Interactive comment on “A simple tool for refining GCM water availability projections, applied to Chinese catchments” by Joe M. Osborne and F. Hugo Lambert

Joe M. Osborne and F. Hugo Lambert

Received and published: 20 July 2018

Fig. 1. Schematic of how the Budyko framework is used to improve our understanding of 20th-century historical changes and 21st-century projected changes.

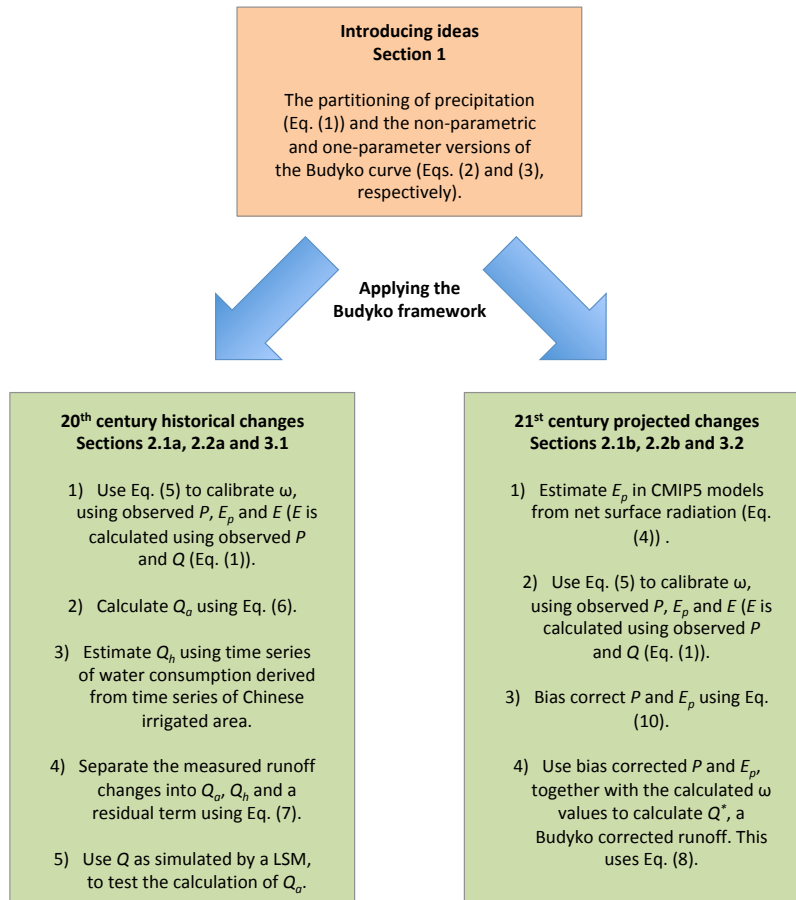
The manuscript is generally in a good shape, well structured and well written. The overall presentation of the results is good with concise and high-quality figures. The methodological approach seems to be technically sound, but (due to its complexity) needs to be explained better. Maybe some sort of conceptual figure or flow chart would help! Further, the obtained results depend on many assumptions which potentially not permit a robust interpretation of the results. The authors already discuss some

The second referee has also commented that the methodological approach could be explained better. We will therefore add a flow chart (Figure 1) to the end of the introduction section in the revised manuscript to serve as an overview for the subsequent breakdown of the paper.

The key message from this is that the Budyko curve, or rather the updated Fu version (equation 3), can be used to both attribute past changes and help refine future changes. These two strands share common ideology but are attempting to tackle different problems and therefore use different equations. The flow chart more clearly emphasises this and even lists the equations that are used in each application. We will also divide the Data (section 2.1) and Methods (section 2.2) subsections into further subsections to more clearly differentiate the two applications.

Fig. 2. Interannual correlation.

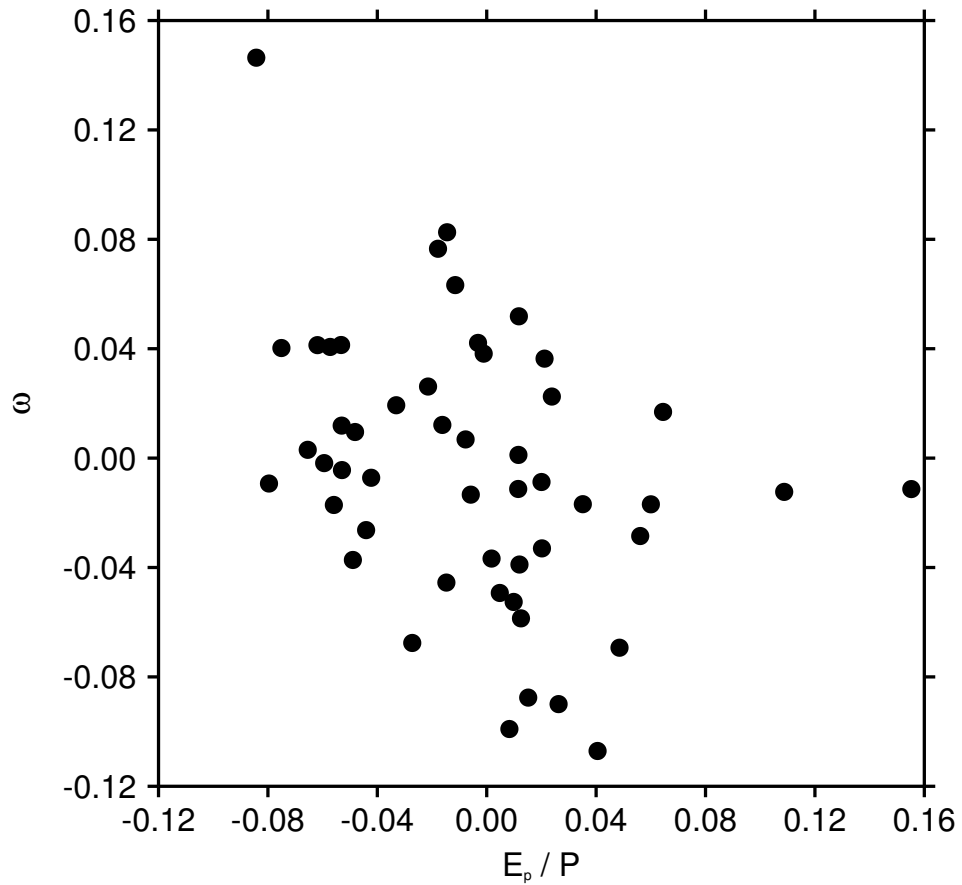
1) I would be very careful with separating the measured change in runoff into the individual components as done in eq. 7. If you assume such a linear relationship, you also assume the individual components to be independent, which they are clearly not! Especially the separation into Q_h and Q_o is potentially dangerous. Please also be aware that in the context of the Budyko framework, aridity is solely defined through the notional, dimensionless ratio E_p/P , which has no direct physical meaning. Everything else besides mean annual E_p/P is actually integrated into w . Also, w and E_p/P are not necessarily independent (please see Padron et al, 2017). It would be nice if you could try to determine if there are dependencies between Q_a , Q_h , and Q_o . Is it possible to plot these against each other? In case there are large dependencies and interrelationships

the obtained results might be less meaningful.

This is a very good point and something that we have explored further. Unfortunately it is difficult to test for dependencies between Q_h and Q_o due to the limited temporal resolution (decadal mean values) of the irrigated area time series of Freydank and Siebert (2008) that is used to calculate Q_h (page 8, line 25). We can however look at the relationship between Q_a and changes due to all other factors besides aridity change (ω), represented by the residual $\Delta Q_h + \Delta Q_o$ in equation 7. The interannual correlation is -0.35 (Figure 2).

Fig. 4. Using decadal means.

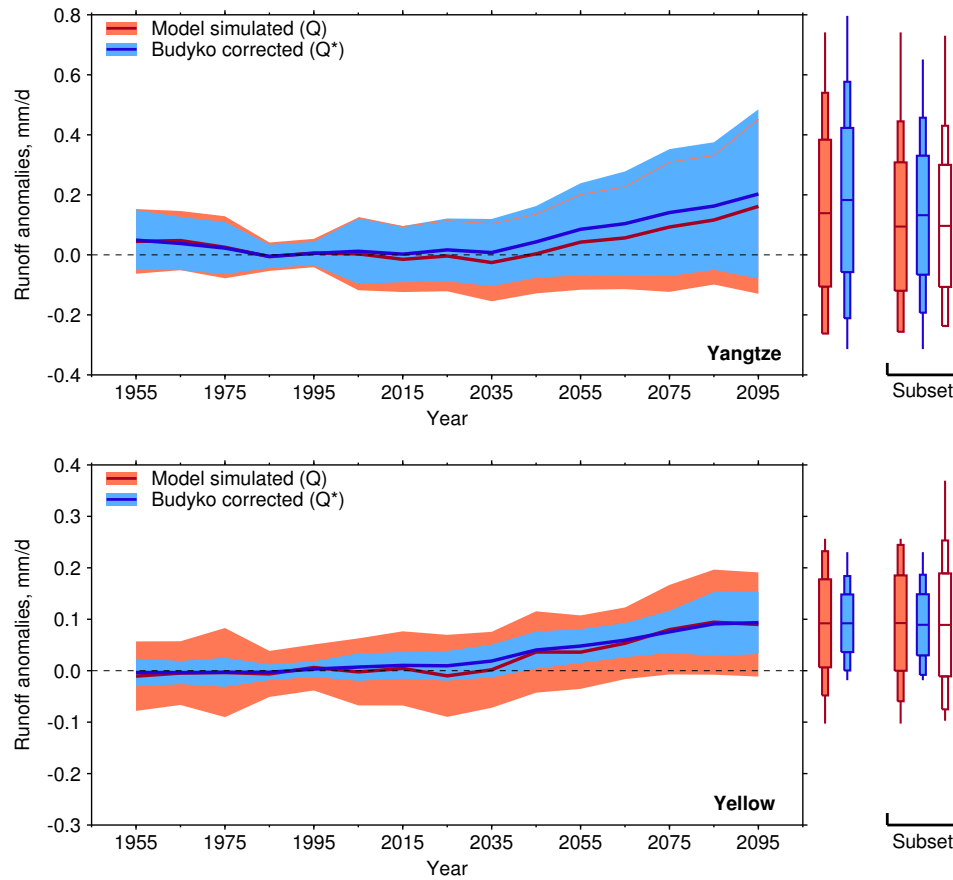
4) You use the Budyko-based equation 8 to compute Q^* for each year. One of the main assumptions of the Budyko hypothesis is stationarity, i.e. storage changes are negligible. This might, however, not be the case here due to interannual variations in storage. Have you maybe tested to use longer time periods to smooth out long-term

variations in water storage? How would your results look like when computing decadal Q^* ?

Because we have no information on changes in storage when we calculate Q as $P - E$ (and assume changes in storage are equal to zero) our results do not change through taking decadal means (Figure 4).

We actually check the potential impact of storage changes by considering values for a subset of 28 (from 34) CMIP5 models for which Q is directly simulated. This information is shown in Fig. 10 and Table 1 and does not affect conclusions, especially for the Yellow catchment, as pointed out in the results.
